STATE OF NEVADA
DEPARTMENT OF TRANSPORTATION

**LAMB BOULEVARD
STREET LIGHTING**

STREET LIGHTS #1 T-1

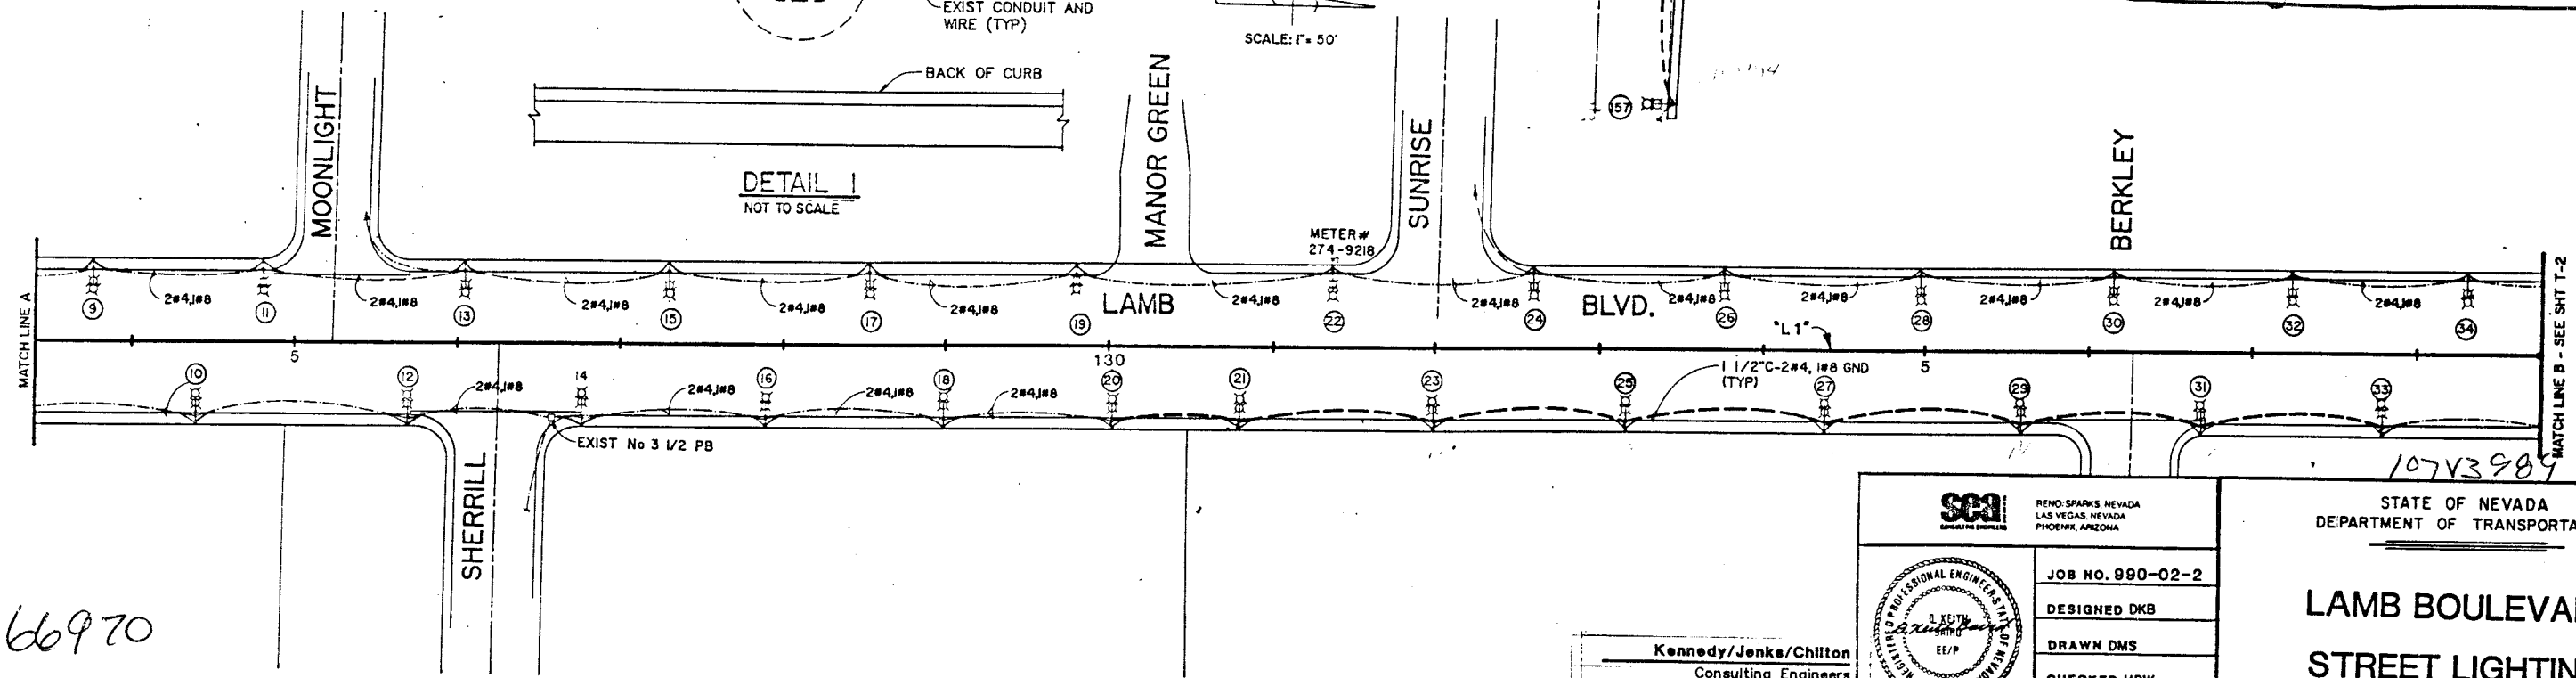
*Remove and Reset Poles
7, 9, 11, 13, 15, 17, 19, 22, 24, 26, 28, 30, 32, 34, 36, 38 and 40
were Deleted from Plans.
Underground Utilities were
in the way for the Resetting
of the Poles
Directed by the Resident Engineer
with City Concurrence.*
